Staff Report
City of Richmond, Virginia

Commission of Architectural Review

5. COA-114615-2022	Conceptual Review	Meeting Date: 7/26/2022
Applicant/Petitioner	Joseph Yates	
Project Description	Construct a new two-story rear addition.	
Project Location		
Address: 516 N. 26 th Street		
Historic District: Church Hill North		
High-Level Details: <ul style="list-style-type: none"> The applicant requests approval to rehabilitate the exterior of a circa 1920 frame dwelling and to construct a two story rear addition. Exterior rehabilitation includes removing existing vinyl siding, and posts, and restoring/replacing in-kind with wood posts and wood siding. Fiber cement siding will be installed on minimally visible elevations. Vinyl windows will be removed and replaced with aluminum clad wood windows. Damaged/deteriorated wooden elements such as the cornice, molding, trim, and sills will be repaired/ replaced in-kind. The applicant proposes to remove a deteriorated, one-story projection from the rear and to construct a two-story rear addition and covered porch. The addition will be as tall as the existing dwelling, and will have a gable roof form, cementitious siding, and aluminum clad wood

Figure 2. Photo approx. 1954

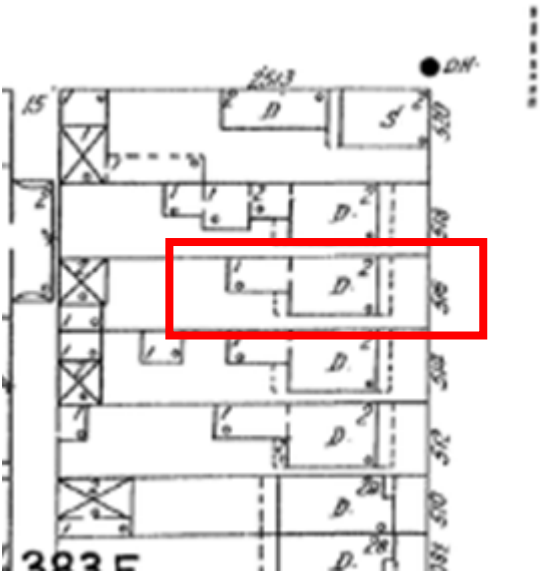
<p>assessor's record which portion of the dwelling was impacted by the fire, but this evidence would confirm that substantial alterations to the historic fabric of the dwelling have already been undertaken.</p> <p>Based on the 1924-1925 Sanborn Maps Staff was able to determine that the rear one-story portion of the dwelling is likely original, and that the shorter portion of the this "L-shaped projection was an open porch, but enclosed sometime after 1950.</p> <p><u>Staff requests that the applicant provide more information and documentation on the existing conditions of the rear one-story portion of the house, including existing elevations.</u></p> <p>According to the applicant's report, the new addition would be approximately 10 feet longer than the existing rear projection. The addition appears quite large, and is the same height as the existing dwelling.</p> <p><u>Staff recommends that the roof of the main addition be lower than the roof peak of the original, two-story portion of the dwelling.</u></p> <p><u>Staff recommends that information on the square footage of the new addition, and the square footage of the existing dwelling be submitted with final review</u></p> <p>During conceptual discussion, staff recommends that the Commission consider the proposed size of the new addition in relation to the remaining original dwelling, as well as consider the merits of the proposed demolition of the rear portion of the dwelling.</p>
